A01 ROSS STREET TEACHING AND LEARNING HUB

SUBMISSIONS REPORT
AUGUST 2025

PREPARED BY MG PLANNING
SUBMITTED FOR UNIVERSITY OF SYDNEY
SSD-57838709

Figure 1: Existing and proposed waste room layout

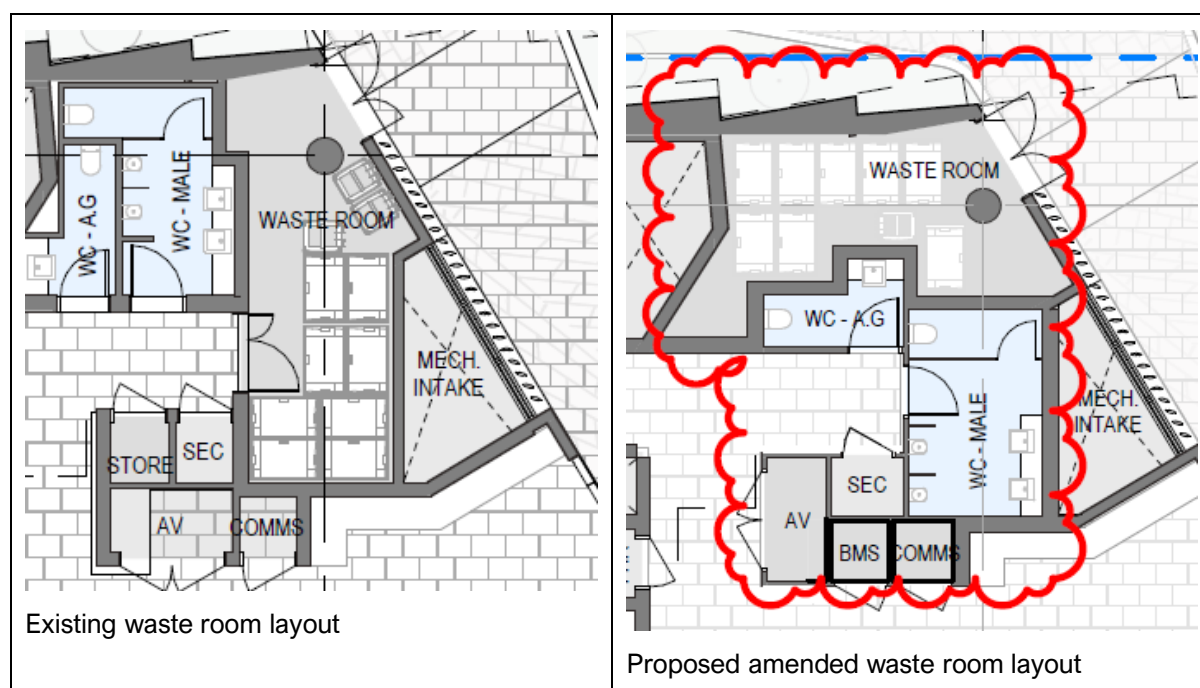
In response to Council's submission, the waste room on Level 2 has been reconfigured and enlarged. The area of the waste room has been increased from 13m² to 18.3m² and the configuration has been modified, adding more space and allowing for improved manoeuvrability. To facilitate this modification,

a minor change has been made to the location of the male and all gender toilets but no other changes have been made. The existing and proposed waste room layout is shown in **Figure 1** below and revised architectural plan for Level 2 is included at **Appendix C**.

Figure 2: Plans of proposed amended fence treatment

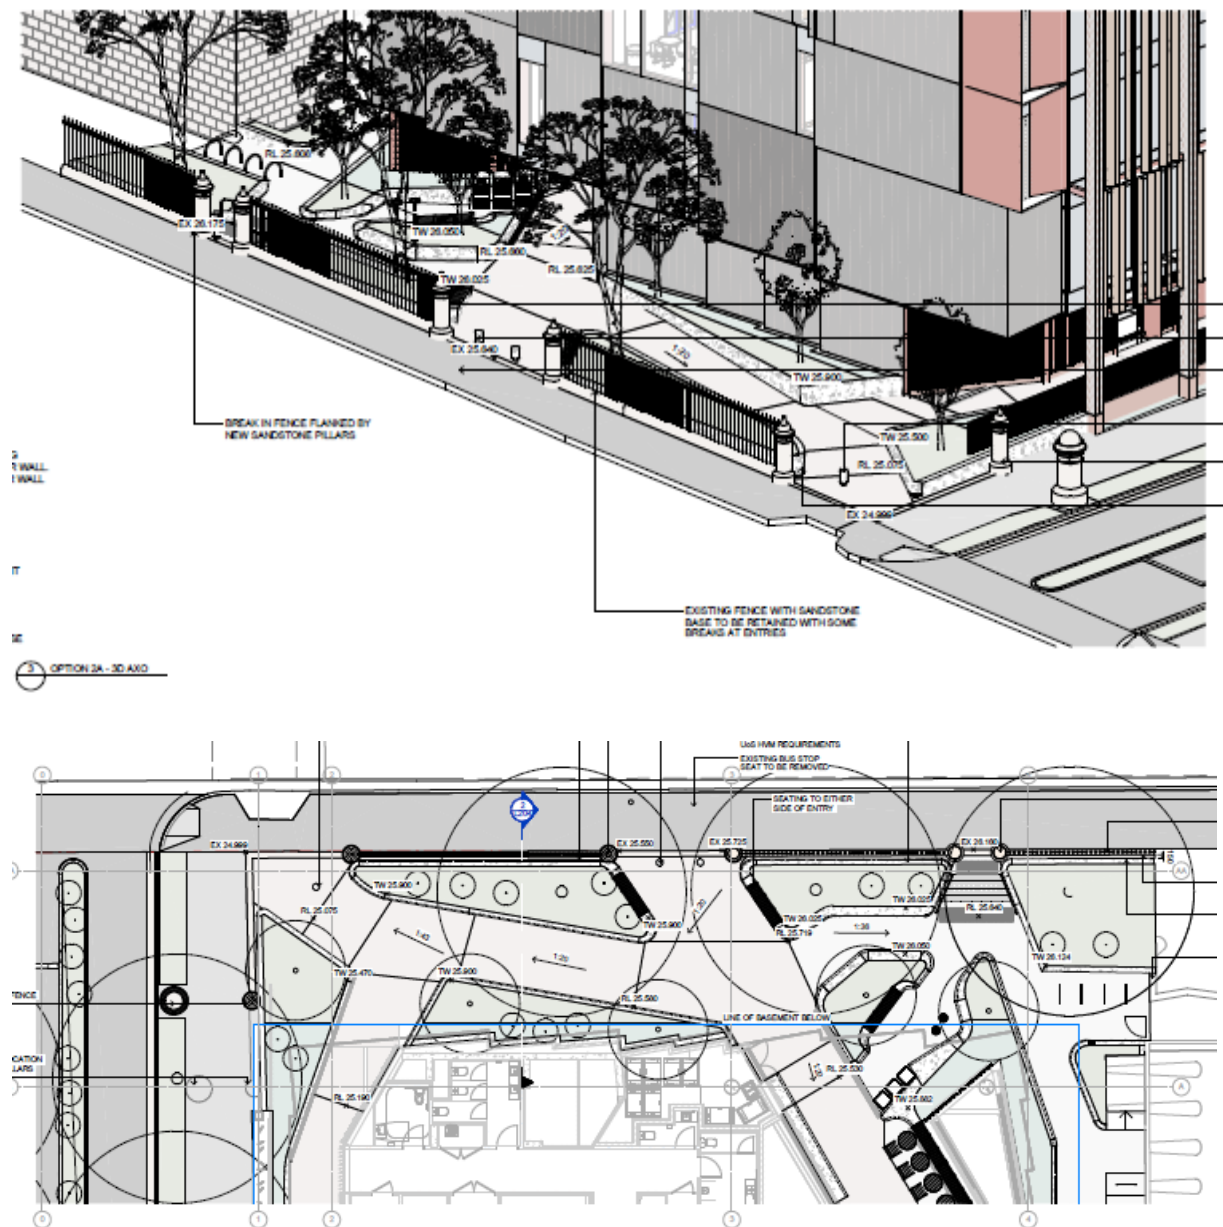
In response to submissions received from both Council and Heritage NSW regarding the heritage significance of the palisade fencing along Parramatta Road, it is proposed to retain the fencing whilst providing for three discrete openings along the frontage. These openings are essential to:

- ensure the safety of pedestrians
- provide for better visual sight lines into and from the University
- allow for additional seating around the bus stop
- provide improved footpath gradients and width
- improve passive surveillance of the site.

The proposed alternative solution for the fencing is shown in **Figure 2** below and in the plans at **Appendix D**.

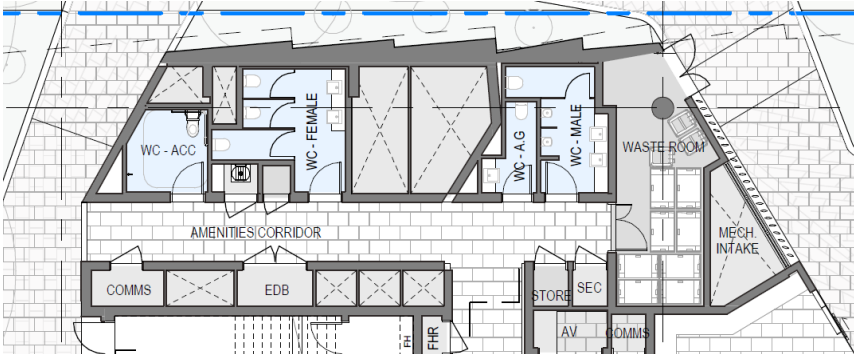
Item	Category	Issue	Response
4.3.1	Heritage Pillars and Gates	The existing heritage listed sandstone gate pillars and wrought iron gates of the Ross Street Gates should be conserved as part of the relocation works. The extent of removal of the heritage listed palisade fencing will have an adverse impact on the heritage significance of the item and is not supported, noting: i) The university is a heritage cultural landscape containing buildings of exceptional individual value set within a designed landscape with large areas enclosed by a historic fence.	<u>Gates pillars and wrought iron gates</u> The gate pillars and wrought iron gates will be conserved as part of the relocation works. Prior to the commencement of construction, a Schedule of Conservation Works will be prepared for the sandstone pillars/gates by a suitably qualified and experienced heritage consultant, to be executed as part of the approved works. In addition, a Photographic Archival Recording will be undertaken of the gates (and palisade fence) in accordance with the Heritage NSW Guidelines for ‘Photographic Recording of Heritage Items Using Film or Digital Capture’. <u>Palisade fencing</u> In response to requests by both Council and Heritage NSW, the University explored other fence options, as discussed below in Section 4.6 below. The

Item	Category	Issue	Response
		ii) The approved Campus Improvement Plan did not include removal of the fence (whereas the gate pillars were shown to be relocated) – refer to drawings SSD- F011 and F012. iii) The proposed mitigation for the loss of the fence by interpreting the alignment of the fence to Parramatta Road, with flush sandstone inlay evoking the sandstone base, and to salvage the sandstone base and ironwork for maintenance and repair of the remainder of the fence, does not adequately mitigate the adverse impact on the significance of the fencing caused by the proposed removal. It is recommended that only sections of the fencing be removed to created new openings tying in with the new internal paths, rather than removing the whole section of fencing fronting the teaching and learning hub. The removed sections may then be incorporated within the landscape design (refer to additional urban design and landscaping comments below).	University still considers that removing the 40m portion of the palisade fence would provide for a more cohesive urban design and public domain solution, due to the pedestrian traffic and accessibility benefits and outcomes. However, recognising the concerns raised by Council and Heritage NSW regarding the heritage significance of the fence, the University has amended the design documentation to retain the fencing but with three discrete openings: (1) at the north-western corner of the building adjacent to the Western Avenue/Parramatta Road intersection; (2) adjacent to the bus stop and (3) an eastern opening to facilitate access between the subject building and the FASS building. The additional options analysis for the palisade fence has been undertaken by Oculus (Landscape Architects) provided in Appendix H and the updated landscape drawing set is included in Appendix D. The proposed openings in the fence as shown on the amended design, are considered essential to: - ensure the safety of pedestrians - provide for better visual sight lines into and from the University - allow for additional seating around the bus stop - provide improved footpath gradients and width - improve passive surveillance of the site. It is considered that the amended design addresses Council's concerns regarding the fence treatment.

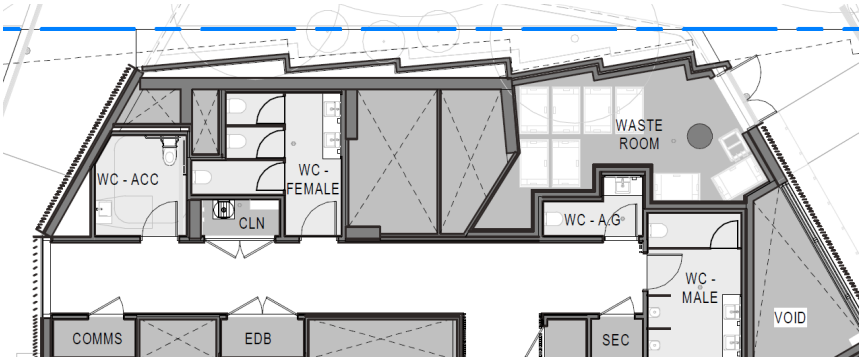
4.3.2	Urban Design - Removal of Palisade fence	The removal of the heritage listed palisade fencing along Parramatta Road is not supported from an urban design perspective. The proposed development includes a landscaped setback along the Parramatta Road frontage to create a more permeable entry, however, the proposed northern elevation of the building presents as a blank frontage at the ground plane. The removal of the fencing and creation of multiple pathway entries interspersed between landscaping does not improve	Refer discussion above. The design has now been amended to retain the palisade fencing and incorporate discrete openings. The amended design aims to conserve the heritage significance of the fence while facilitating visual and physical access and improving the safety and amenity of the bus stop. Sandstone pillars are proposed either side of each opening to integrate with the historic design of the fencing. One concrete bollard at the western opening and two bollards at the central opening are proposed to mitigate hostile vehicle entry to the site. The bollards are small and will not detract from the overall appearance of the fence.

Item	Category	Issue	Response
		the access to the proposed building. In doing so the heritage edge and its significance is lost. The Design Excellence and Review Committee also raised concerns regarding the removal of the fencing as measures would then be required to prevent people running across Parramatta Road. The removal of the fencing also requires the introduction of hostile vehicle defence measures further detracting from the design intent.	Transport for NSW has indicated its support for opening up the fence adjacent to the bus stop to improve pedestrian safety and functionality of the space. No concerns have been raised with respect to pedestrians running across Parramatta Road. It is considered that the amended design with the narrower openings and bollards will reduce risks of pedestrians crossing Parramatta Road in this location.

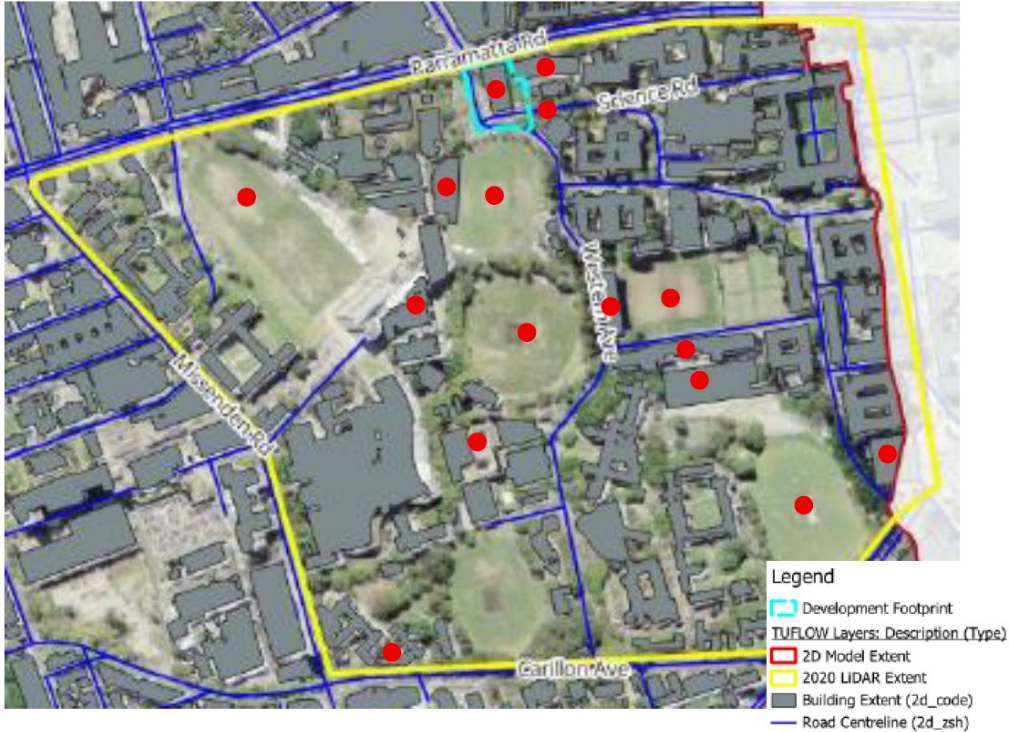
4.9.2	Proposed Zebra Pedestrian Crossing	TfNSW does not support the proposed zebra pedestrian crossing. The zebra crossing proposed approx. 40m south of the signals raises efficiency concerns as it is likely to adversely impact traffic on Parramatta Road due to increased pedestrian activity in this area leading to drivers finding it difficult to find safe gaps to pass the zebra crossing and continue south on Western Avenue, which could result in queues extending into the Parramatta Road/Ross Street/Western Avenue intersection. Additionally, visibility to pedestrians for northbound drivers on	SCT Consulting has prepared a technical memo exploring whether the zebra crossing proposed could cause queue spillback onto Parramatta Road (refer Appendix Q). It finds that the critical threshold at which queue spillback is expected is much higher than the anticipated uplift in pedestrian activity in the area and recommends proceeding with the zebra crossing. In its email of 31 July 2025 (Appendix B), TfNSW advised as follows with respect to the zebra crossing:

Item	Category	Issue	Response
		Western Avenue will be obscured by the queued vehicles, raising further safety concerns. As such, should there be a need for pedestrian connectivity, consider alternative options that would not take away priority to entering vehicles, such as a pedestrian refuge.	▪ TfNSW is amenable to the marked pedestrian crossing in Western Avenue as depicted on Drawing Number AR-02A-XX-04 Issue 07 [refer Architectural Drawings at Appendix D of the EIS]. ▪ Appropriate measures should put in place to ensure that pedestrians cross Western Avenue via the marked pedestrian crossing. ▪ There is a typo error on Technical Note dated 26/06/25 summarised in the Recommendations on Page 3 (screenshot below) that the 95th percentile queues of 2.9m and 2.7m in AM and PM peak. Please check if these numbers are correct. Having regard to TfNSW's advice, no changes to the zebra crossing are required. With respect to the Technical Note error, SCT Consulting has advised as follows: <i>... confirming that the 2.9m and 2.7m queues reported are not a typo and extracted directly from our SIDRA model. The queue is short due to the relatively low volume of vehicle movements (and pedestrians) and SIDRA is not expecting the interaction between this volume of vehicles and the estimated number of pedestrians crossing to cause any significant queues build up.</i> In light of SCT Consulting's advice and the outcome of the SIDRA model, it is considered that the identified queues are satisfactory given the volume of vehicles and pedestrian numbers.

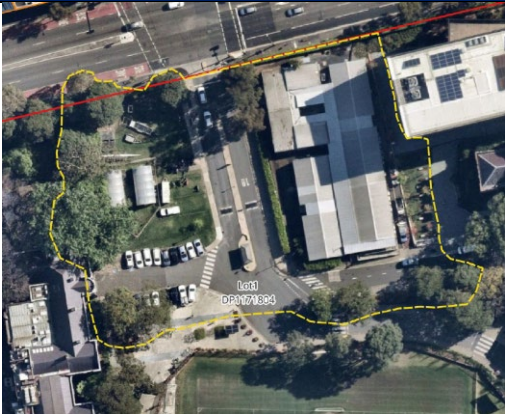
4.10.3	Hazard categorisation	CPHR observed that under existing conditions, Science Road is categorised as H5 and H6. A comparison of the FIRA's hazard figures pre- to post-development indicates that previously spread-out high hazard areas on Science Road	<i>Recommendation 7: Discuss the concentration of high hazard flows on Science Road and evaluate additional impacts of the development on this change.</i> CPHR is correct in its observation that the hazards are being concentrated at the end of the realignment of Science Rd and that along Science Rd hazards have shifted from the northern

Item	Category	Issue	Response
		have become more concentrated and potentially increase overall across all flood events. Although the maximum hazard category remains unchanged, any increase in depth or velocity is not desirable and efforts have not been made to mitigate these impacts. H5 and H6 hazard categorisations are dangerous for people, vehicles and buildings. While these impacts are confined within the subject site, they would impact existing facilities and roads within the University Campus. The full extent of increase in depth and velocity should be provided, along with modelling of a more frequent flood event to determine if more frequent events result in a change in hazard category. Recommended actions: 7. Discuss the concentration of high hazard flows on Science Road and evaluate additional impacts of the development on this change. 8. Include the full extent of increase in depth and velocity within the subject site. 9. Model more frequent flood events in accordance with the requirements of the LU01 Guideline. 10. Include proposed stormwater drainage in the flood model. 11. Provide mitigation measures to demonstrate that changes in flood behaviour are addressed.	gutter of the road towards the southern gutter. As a result floodwater is concentrating on the western gutter of this realignment rather than being spread between two gutters. While there are no additional impacts on the development due to this change, it is a local change and may influence the road design during the University Campus upgrade work in Science Rd. However, this is not part of the subject development and is therefore outside the scope of the FIRA. <i>8. Include the full extent of increase in depth and velocity within the subject site.</i> Velocity and level impact maps have been provided in excess of the LU01 recommendations with maps for the 20% AEP, 1% AEP, 0.2% AEP and PMF. The impacts do not extend beyond the mapped areas and as reported are all local impacts around Science Rd and University Oval 2, except for some minor benefits for offsite flows at the USYD campus outlet at Parramatta Rd near Larkin St. <i>9. Model more frequent flood events in accordance with the requirements of the LU01 Guideline.</i> The FIRA already provides a more frequent flood event than recommended in the LU01 Guidelines. The LU01 Guidelines recommend the 10% AEP to the PMF as the full range of events (Section 2.3 and Appendix A Table 6). The FIRA provides the 20% AEP to the PMF. In excess of the LU01 Guidelines GRC Hydro has provided impact mapping for the 20% AEP as well as the mapping extends to include all the areas impacted. <i>10. Include proposed stormwater drainage in the flood model.</i> The proposed stormwater site drainage is not included by design. As noted above there are no flowpaths through the site in the flood model. The assumption is that ALL rainfall in excess of the site's infiltration capacity is conveyed as overland flow to Science Rd. This is a very conservative assumption that there will be overland flow in excess of what might be managed by the site's stormwater drainage in flood events. Changes to the infiltration capacity are noted in Table 5, Page 10 of the FIRA with the changes to impervious and pervious percentages which note an increase in Impervious surfaces of 6%
